DIMENSION BUILDERS
1900 W. UNIVERSITY AVE. STE. 103
GEORGETOWN TX, 75227
(512) 864-9191

KOPEC RESIDENCE
2800 VIVICREST
001-10000
PLAN NO.

FLOOR PLAN
1/8"=1'-0"

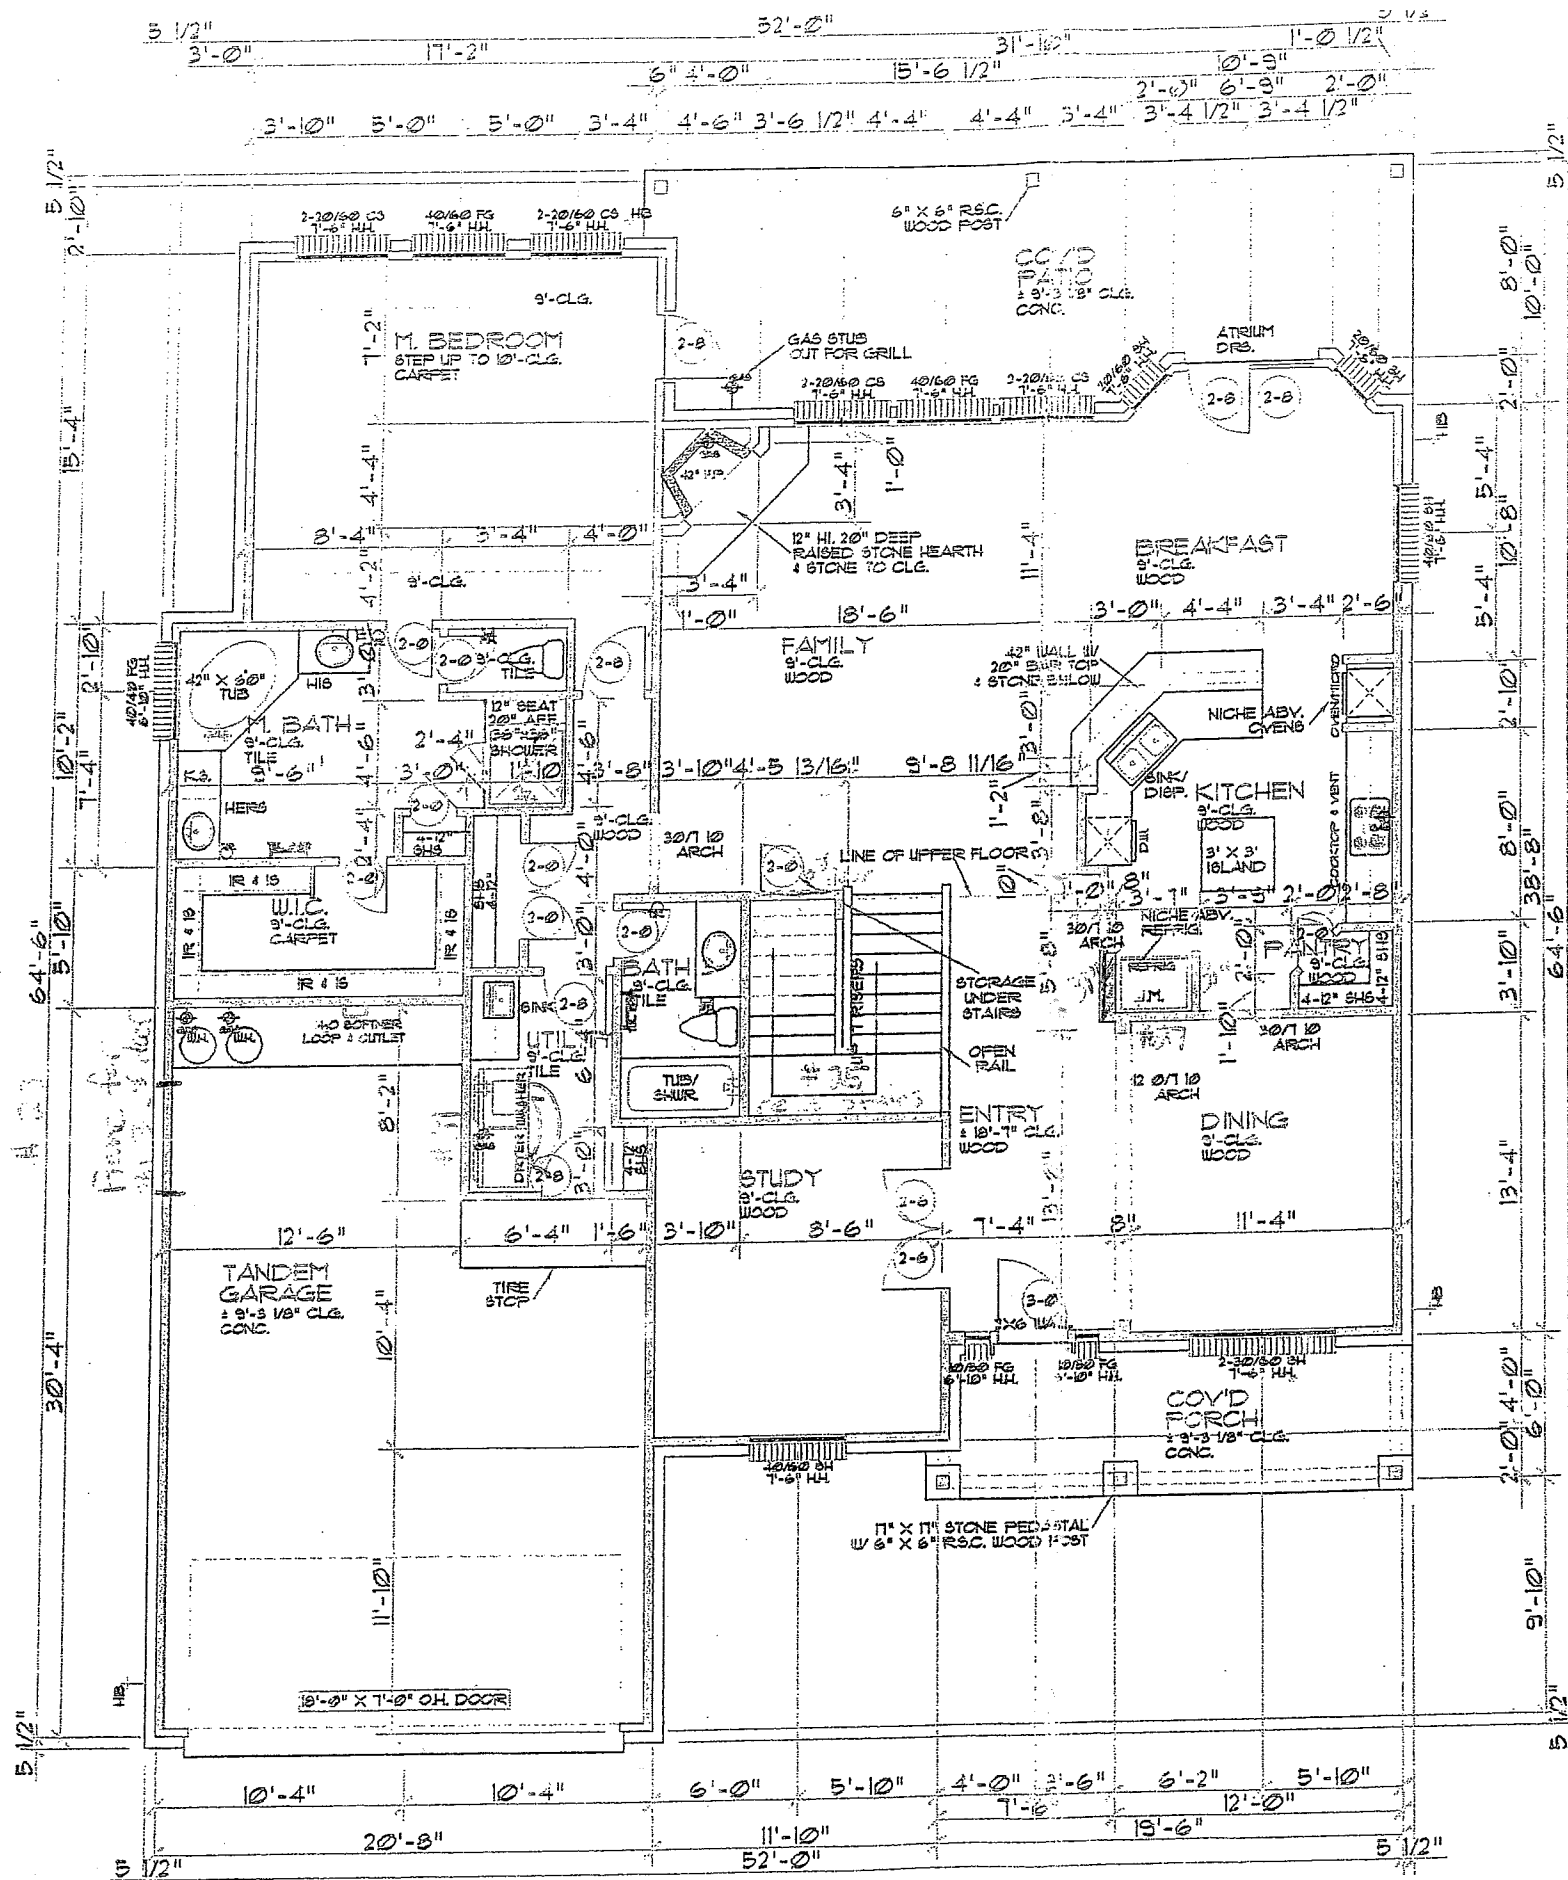
- #15 windows - same as 2nd
- #23 30" x 11" steel @ garage
- #25 12" x 12" stone / with 6" deep inset
- #26 pocket door changes 3/4" 3/4"
- #27 opening to be 31" or 7

NOTE: correction made to

#31 swap staircase
wooden
brackets
